## 22 BUSINESS ORGANIZATIONS

**Palmdale - Burbank - RECORD #4040 DETAIL**

## Response to Submission 4040 (William Slocum, Kagel Canyon Civic Association, September 6, 2022)

Figure 1. Real-time Deer Incidents & Wildlife-Vehicle Conflict (WVC) Hotspot maps, with live data feeds from the California Roadkill Observation System (CROS) and the California Highway Incident Processing System (CHIPS), University of California Davis, Road Ecology Center, September 16, 2023.

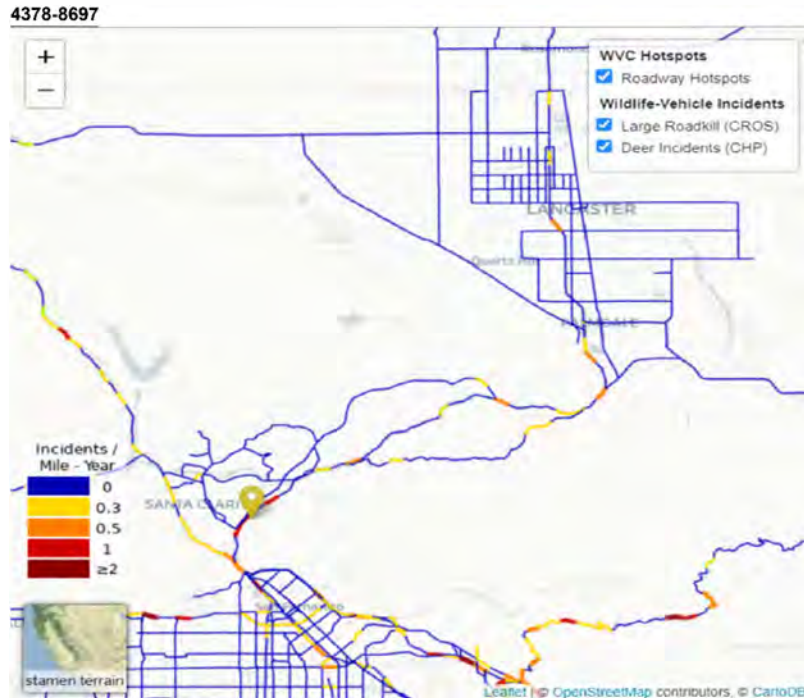
The commenter asserts that since the SR 14 freeway is not impermeable (i.e., there is no 10-foot-tall fence), some valuable wildlife movement in the area likely persists (e.g., animals may successfully cross when there is low or no traffic). Subsequent to the development of the WCA, the University of California Davis, Road Ecology Center created the Real-time Deer Incidents & Wildlife-Vehicle Conflict (WVC) Hotspot maps, with live data feeds from the California Roadkill Observation System (CROS) and the California Highway Incident Processing System (CHIPS) (UC Davis 2023) (Figure 1, below). The map does not show wildlife species. The data shows the following rate of incidents per mile per year:

No large roadkill or deer incidents were reported along the stretch of the SR 14 freeway between Palmdale and Santa Clarita, concluding that the hotspots listed above are comprised of small to medium wildlife. The nearest deer incident reported on CHIP was on Placerita Canyon Road near Santa Clarita, east of the SR 14 freeway, recorded on September 16, 2023 (Figure 1, below).

Figure 3 –UC Davis' Real-time Deer Incidents &Wildlife-Vehicle Conflict (WVC) Hotspots map, September 16, 2023

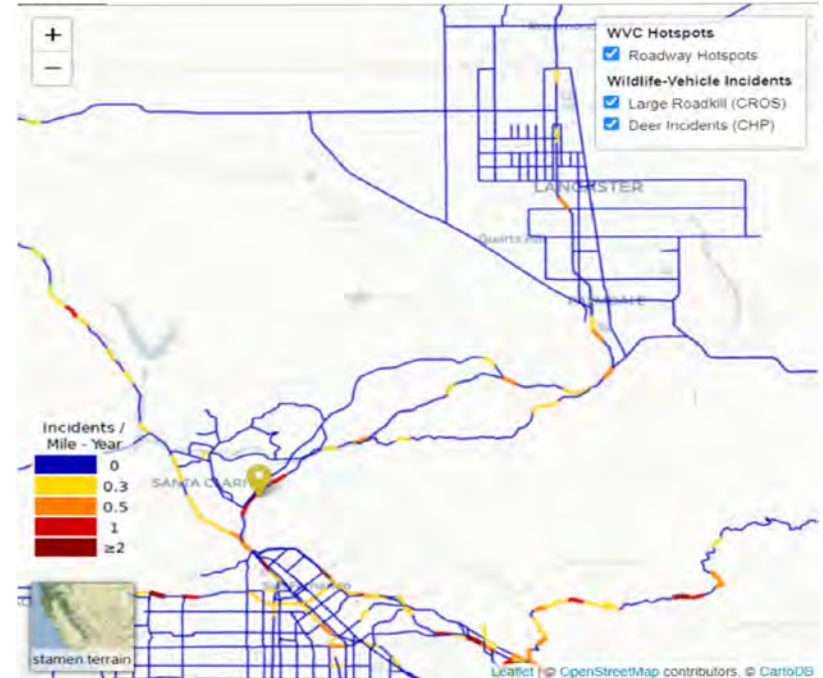
The primary crossing opportunities under the SR 14 freeway in the vicinity of Bee Canyon include Agua Dulce Canyon Road to the northeast and Stone Crest Road to the southwest. Furthermore, Figure 4-5 in the WCA shows the spatial relationship between these wildlife crossing opportunities at the existing bridges on the SR 14 freeway and the tunnel and viaduct segments of the alignment and how the existing wildlife movement opportunities are maintained as a result. Attached Figures 1 and 2 below further illustrate how existing wildlife movement opportunities across the SR 14 freeway line up with the adjacent permeable tunnel and viaduct segments for the SR14A Build Alternative to maintain wildlife movement and gene flow.
